Teckler Boulevard Self Storage – Preliminary/Final PUD Phase 2 Project Review for Planning and Zoning Commission

<u>Meeting Date:</u>	January 18, 2017 and February 1, 2017
<u>Request:</u>	Special Use Permit to allow a Preliminary and Final PUD for multiple buildings on a zoning lot, for mini-warehousing/self-storage and for outside storage.
<u>Location:</u>	Southwest corner of Official Road and Eastgate Alley
<u>Acreage:</u>	5.79 acres total; Phase 2 approximately 2 acres
<u>Existing Zoning:</u>	M and M-PUD Manufacturing
<u>Surrounding Properties:</u>	North: M-PUD Manufacturing South: M Manufacturing East: (Across Main Street) B-2 Highway Commercial West: M Manufacturing
<u>Staff Contact:</u>	Elizabeth Maxwell (815.356.3615)

CRYSTAL LAKE SELF STORAGE CRYSTAL LAKE, ILLINOIS AMENDED PRELIMINARY/FINAL PUD

PROJECT NUMBER
FITZ-16029-3
SHEET TITLE
OVERALL
SITE
PLAN
SHEET NUMBER
1 OF 2

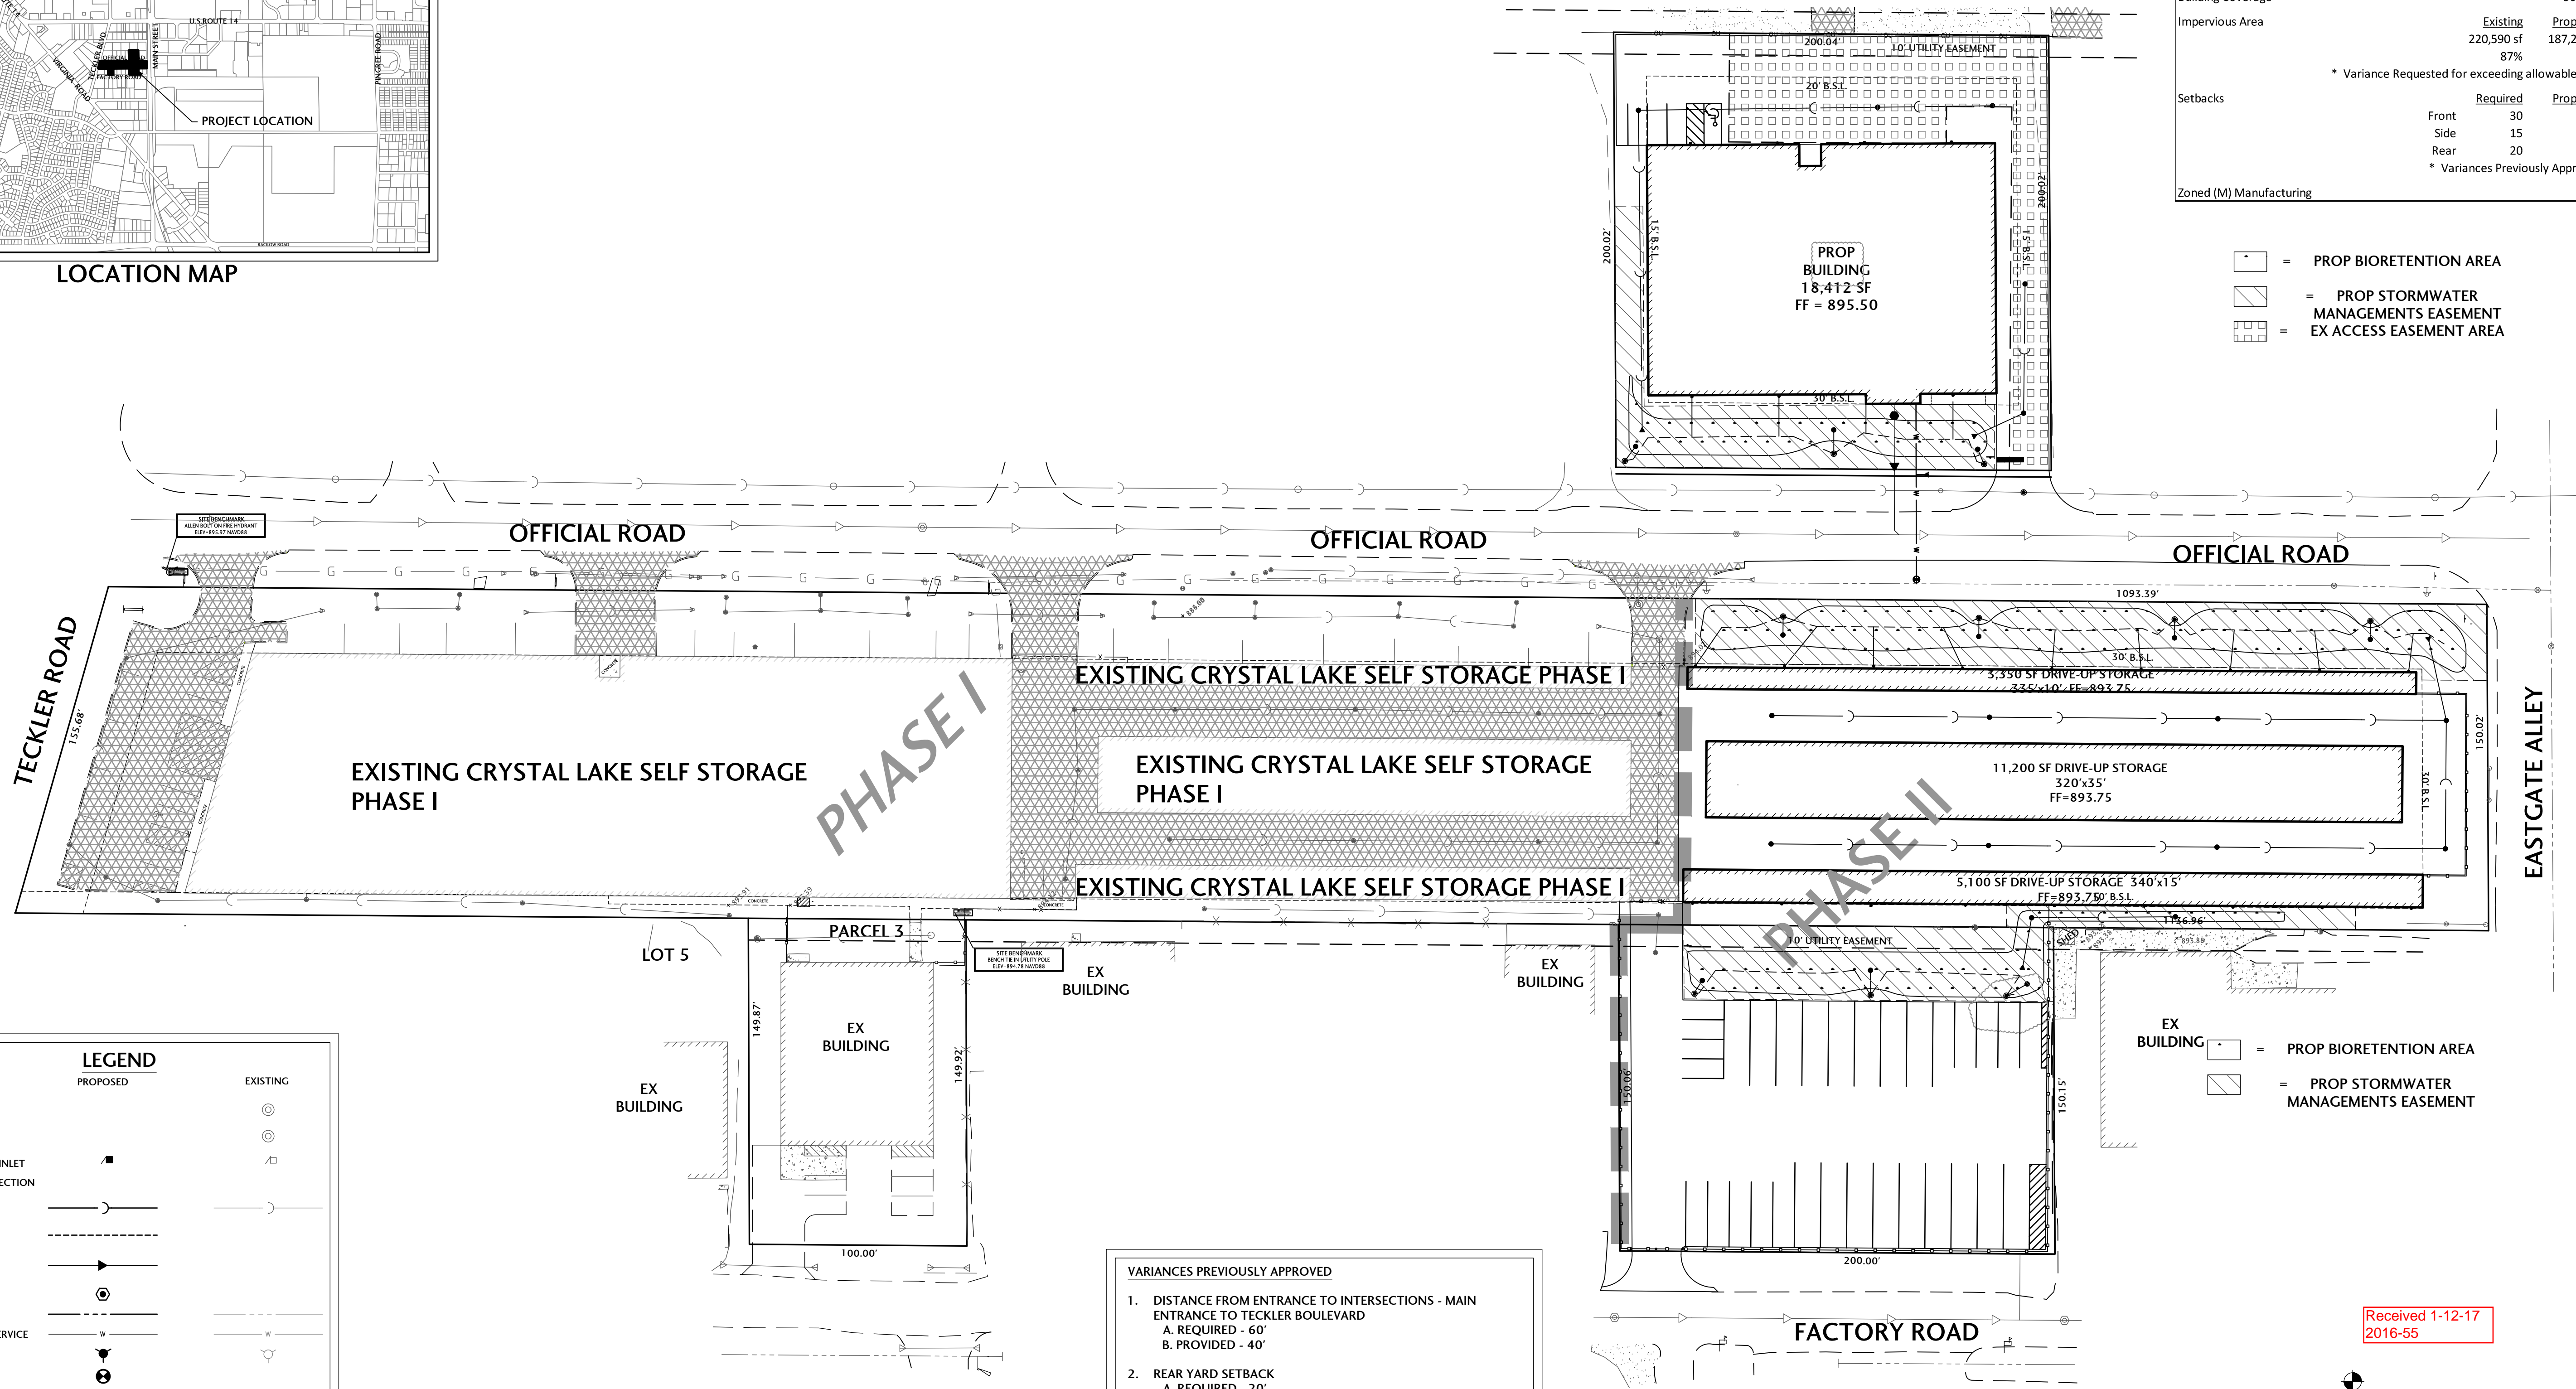
- Variation from Section 3-200B Density and Dimensional Standards to allow 74% impervious surface from the permitted 70%, a variation of 4%. The previous site was 87% impervious, so in reality, the impervious surface coverage is being reduced with this development.
- Variation from Section 4-200C to curb and landscape around the customer parking area, which is located in the outside storage lot.

SHEET TITLE
**Landscape
Plan**

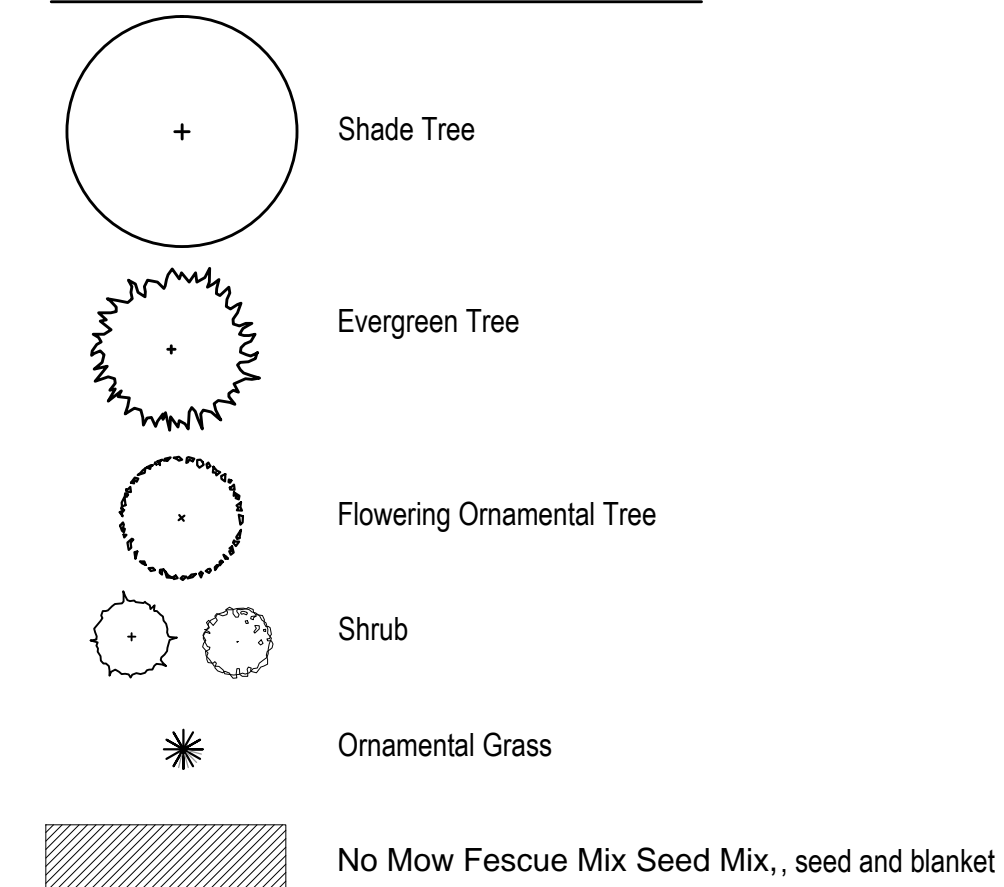
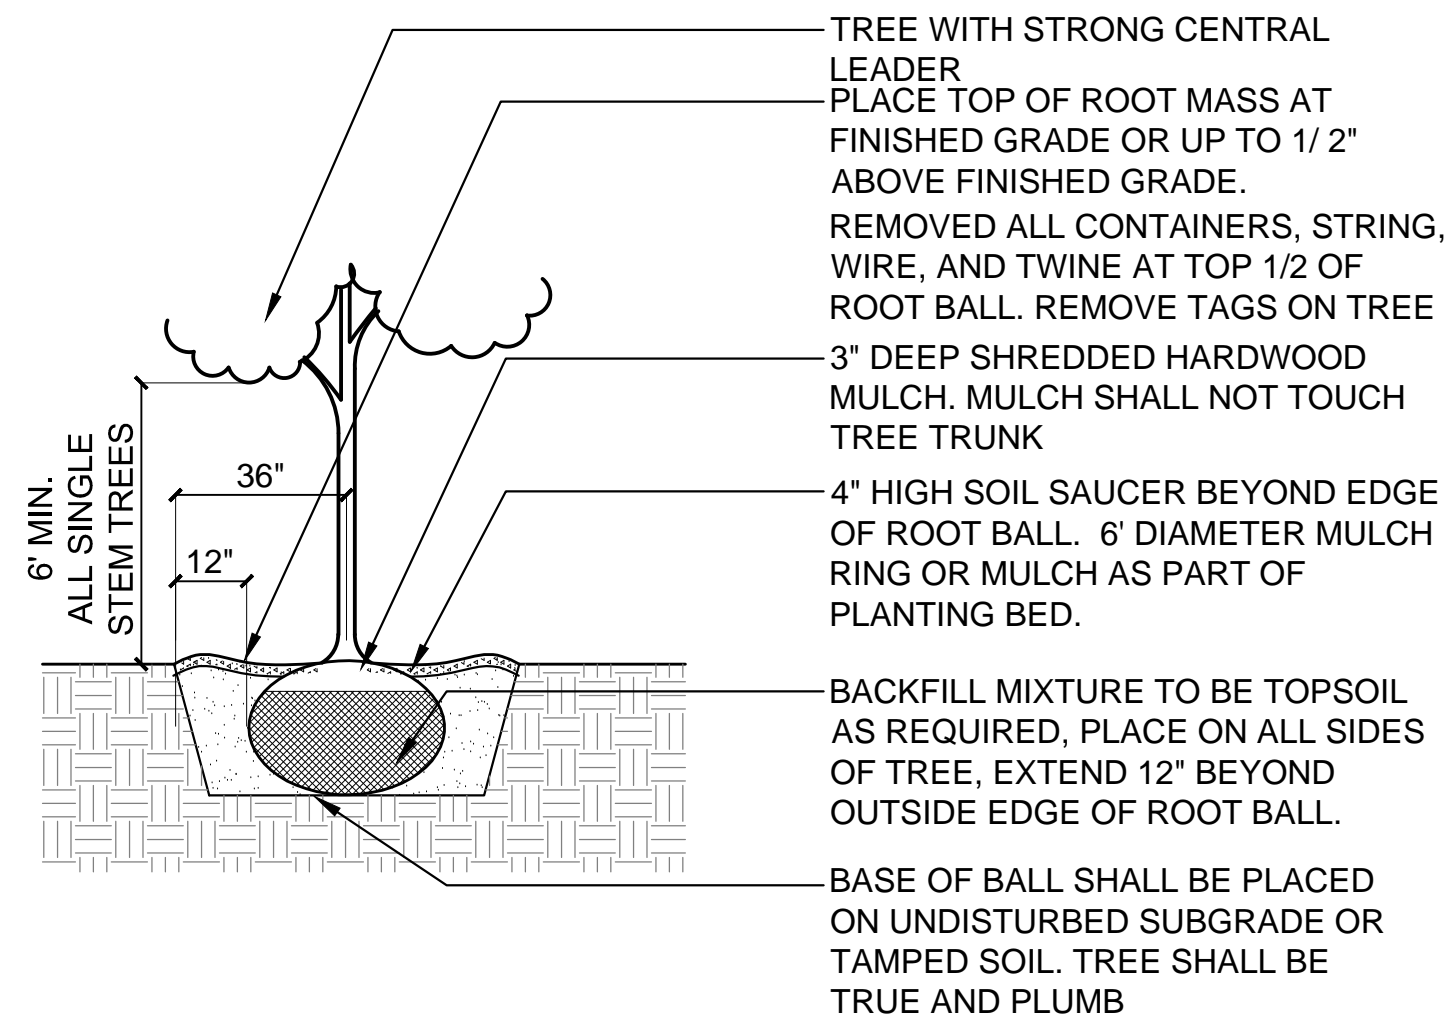
- The petitioner has submitted a preliminary landscape plan. It illustrates parkway trees along Official Road spaced about every 40 feet as well as on site landscaping.
- Foundation base landscape is shown where possible around the drive-up mini-storage buildings with the most heavily and detailed landscape areas along Official Road.
- The petitioner has wrapped a variety of trees and shrubs around the east side of the site to better screen the buildings from Main Street along the Eastgate Alley elevations.
- Foundation base landscape is illustrated along the south and west elevations of the new climate controlled building.

1. Approved plans, reflecting staff and advisory board recommendations, as approved by the City Council:
- A. Application (Teckler Blvd. Development, received 03/03/14)
 - B. Site Plan (J. Condon & Associates, Inc., dated 1/12/17, received 1/12/17)
 - C. Landscape Plan (J. Condon & Associates, Inc., dated 1/11/17, received 1/12/17)
 - D. Architectural Plan Set (Reitan Architects, LLC, dated 12/07/16, received 12/09/16)
 - E. Engineering Plan Set (J. Condon & Associates, Inc., dated 1/12/17, received 1/12/17)
 - F. Engineering Report (J. Condon & Associates, Inc., dated 1/17/17, received 1/12/17)
2. Site and Landscape Plan
- A. Add additional landscape materials along Factory Road to screen the outside storage area. These should be taller evergreens to provide a solid year-round screen.
